MODIFICATION SHEET No. RDSO/2011/EL/MS/0397(Rev. '0'), Dated: 06.06.2011

Modification in 3-phase electric locomotive to record message of VCD isolation status.

Amendment No: -1

Sub: - Amendment no. 1 of Modification Sheet no. RDSO/2011/EL/MS/0397
(Rev-0) dated 06.07.2011.

Modified wiring diagram

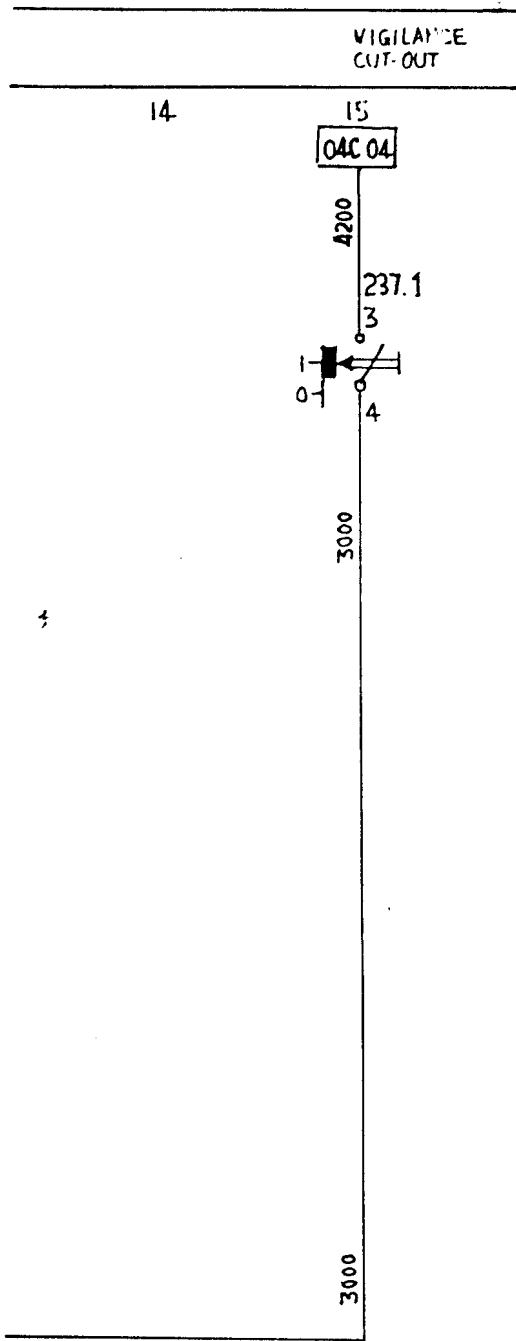
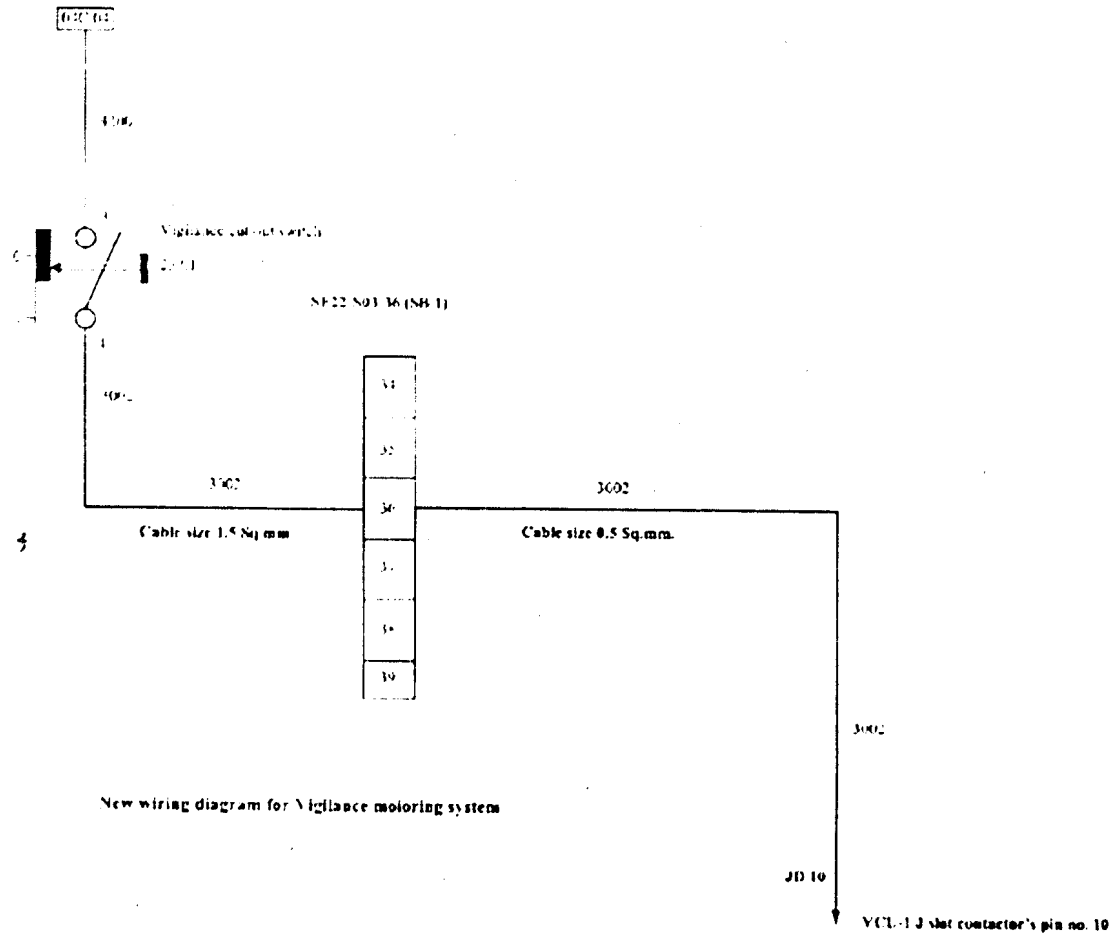
At present there is no provision of recording of message of VCD isolation in DDS in 3 phase locos. If loco pilot isolates the VCD and work the train without VCD in service, then with the help of DDS, status of VCD isolation cannot be ascertained. Therefore modification in 3-phase electric locomotives is required in software and electrical circuit so that in case loco pilot isolates the VCD, the isolation message of VCD should be recorded in the DDS .

The isolation switch has to be connected to pin no.-10 of slot J connector in VCU-1 (Control Electronic) through SB-1 as per wiring shown at Annexure-II and modified software by CLW is to be loaded in STB-1 processor.

Modified wiring diagram for VCD circuit

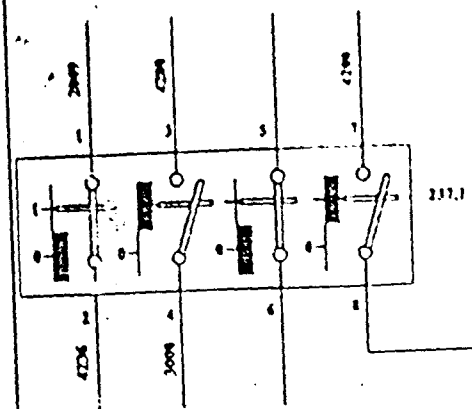
Sn	Amendment	
	Existing arrangement	Modified arrangement
1	Wiring diagram As per Annexure-II Terminal no. 4 of rotary switch 237.1 is connected to terminal no.36 of SB-1	1. As per CLW drawing no. C-D&D/E/ Vig.001(Page-1) 2. An additional link is to be provided from MCB 127.15 to 237.1 terminal no. - 7 as shown in drawing no. C-D&D/E/ Vig.001(Page-2)
